Project	IEEE 802.16 Broadband Wireless Access Working Group < http://ieee802.org/16 >	
Title	Corrections to Figure 87	
Date Submitted	2004-06-25	
Source(s)	Lei Wang, Adam Newham Cygnus Multimedia Communications, Inc.	Voice (760)448-1984 Fax: (760)448-1989 Email: lwang@cygnuscom.com
Re:	This is a contribution to IEEE 802.16 Cor1.	
Abstract	For the OFDMA PHY CDMA-based initial ranging, the timer T9 shall be started at BS after sending RNG-RSP (success).	
Purpose	To correct Figure 87.	
Notice	This document has been prepared to assist IEEE 802.16. It is offered as a basis for discussion and is not binding on the contributing individual(s) or organization(s). The material in this document is subject to change in form and content after further study. The contributor(s) reserve(s) the right to add, amend or withdraw material contained herein.	
Release	The contributor grants a free, irrevocable license to the IEEE to incorporate material contained in this contribution, and any modifications thereof, in the creation of an IEEE Standards publication; to copyright in the IEEE's name any IEEE Standards publication even though it may include portions of this contribution; and at the IEEE's sole

Figure 87 CDMA Initial Ranging -- BS

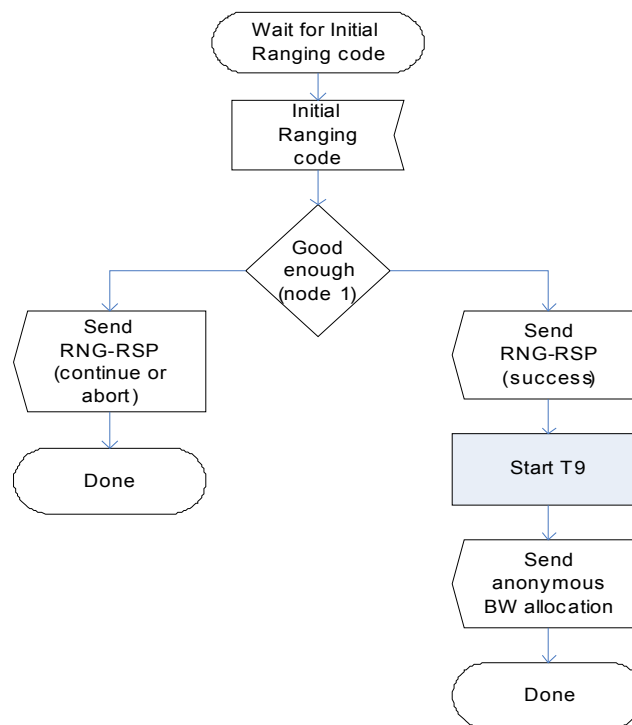
The timer T9 shall be started at BS after sending RNG-RSP (success) to the SS during initial ranging. However, in Figure 87 of IEEE Std 802.16-2004 for the OFDMA PHY CDMA-based initial ranging, the timer T9 was not started at all. This contribution provides a modified Figure 87 to correct this problem.

Replace Figure 87 with the following figure:
